# Rezoning Transportation Analysis

Petition Number: 2023-071

Date	Description
8-24-23	First Review (TM)
12-19-23	Second Review (KC)
04-23-24	Third Review (IW)

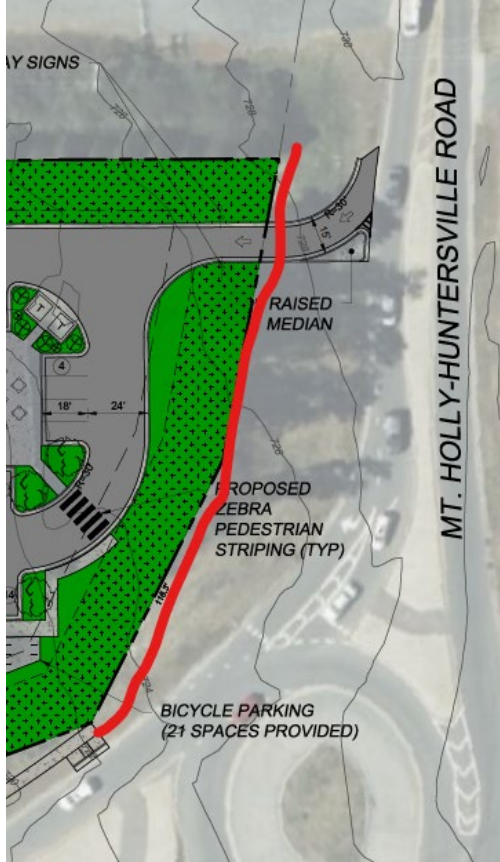
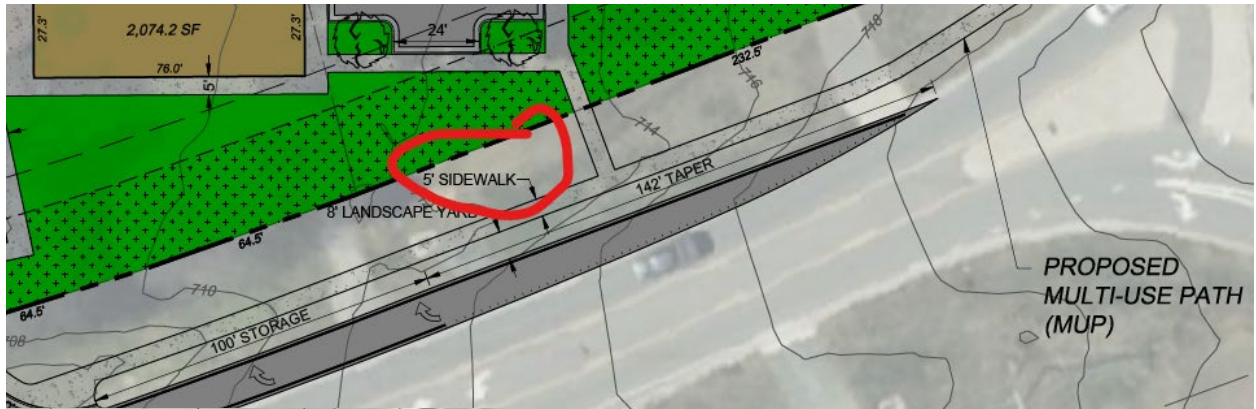
~~The petition's zoning falls within low intensity development which based on the 1560 daily trips will trigger Tier 3 (9 mitigation points) for multimodal assessment. The petitioner shall review and assess the publicly accessible pedestrian network within ¼ mile walking distance of the site to identify multimodal infrastructure to meet the Tier 3 (9 mitigation points) for multimodal assessment.~~

~~Outstanding Comment 12-20-23: TIS scope was approved on 11/14/23. TIS and CTR still outstanding.~~
